Planning Application Update Note

STENNER BROW
STENNER LANE, DIDSBURY,
M20 2RQ

PROPOSED FRONT AND WEST ELEVATIONS

0206_ 21_220

01 PROPOSED FRONT ELEVATION

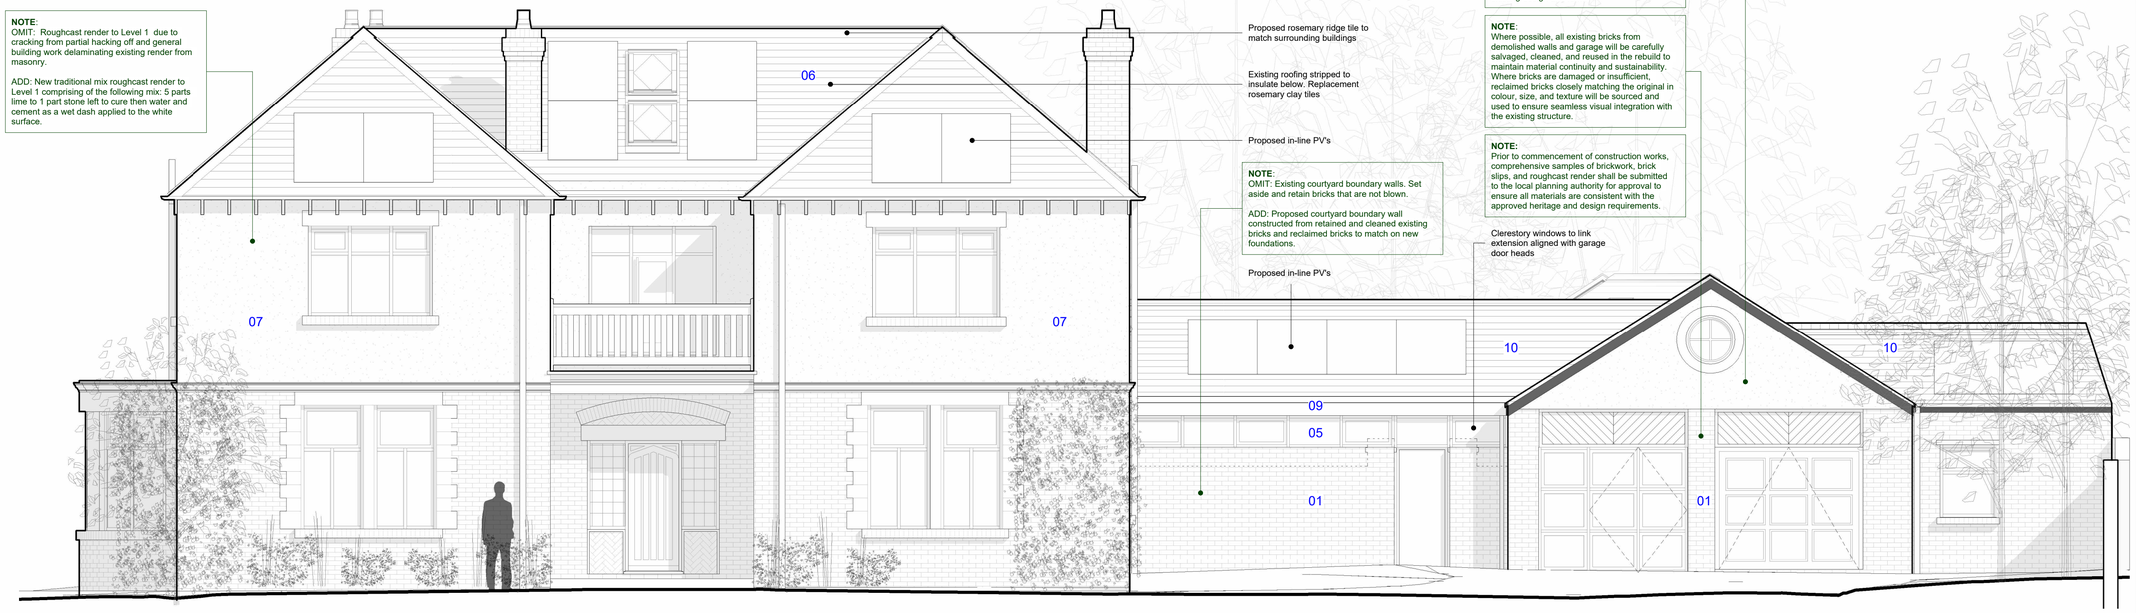
NOTE:
OMIT: Roughcast render to Level 1 due to cracking from partial hacking off and general building work delaminating existing render from masonry.

NOTE:
OMIT: Existing courtyard boundary walls. Set aside and retain bricks that are not blown.

NOTE:
OMIT: Existing garage structure to include all existing floor slab, external and internal walls, and roof elements. Set aside and retain bricks that are not blown.

ADD: New traditional mix roughcast render to Level 1 comprising of the following mix: 5 parts lime to 1 part stone left to cure then water and cement as a wet dash applied to the white surface.

ADD: Proposed courtyard boundary wall constructed from retained and cleaned existing bricks and reclaimed bricks to match on new foundations.

ADD: New garage walls and slab constructed from retained and cleaned existing bricks and reclaimed bricks to match on new foundations to the existing design and footprint to ensure seamless visual integration with the original existing design and form.

02 PROPOSED WEST ELEVATION

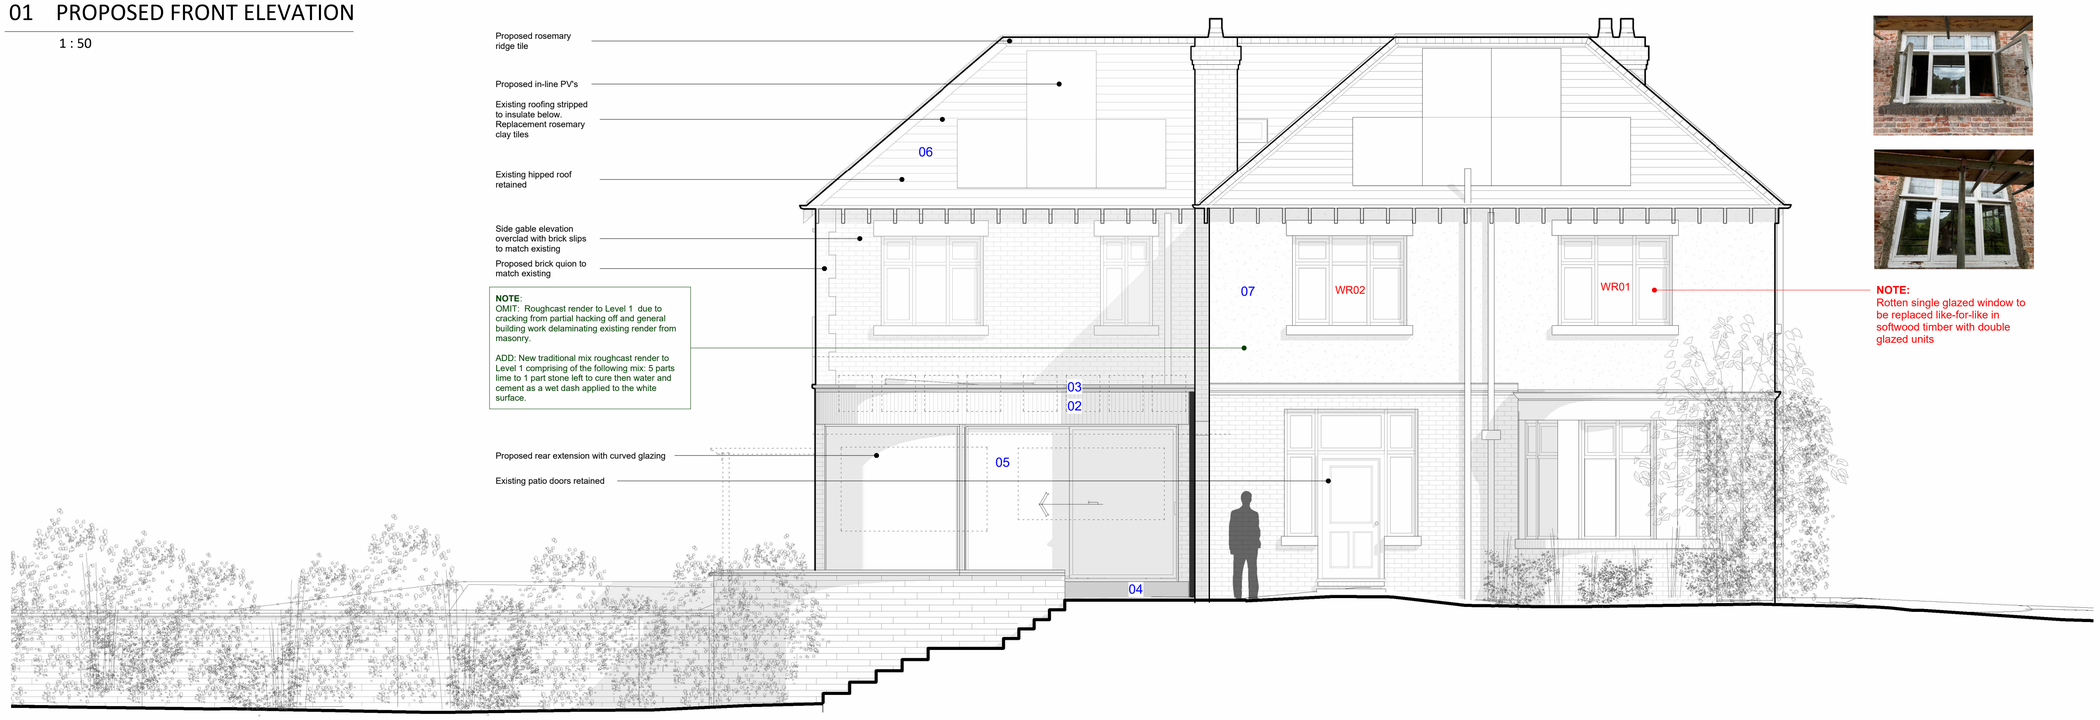
NOTE:
OMIT: Roughcast render to Level 1 due to cracking from partial hacking off and general building work delaminating existing render from masonry.

NOTE:
Rotten single glazed window to be replaced like-for-like in softwood timber with double glazed units

ADD: New traditional mix roughcast render to Level 1 comprising of the following mix: 5 parts lime to 1 part stone left to cure then water and cement as a wet dash applied to the white surface.
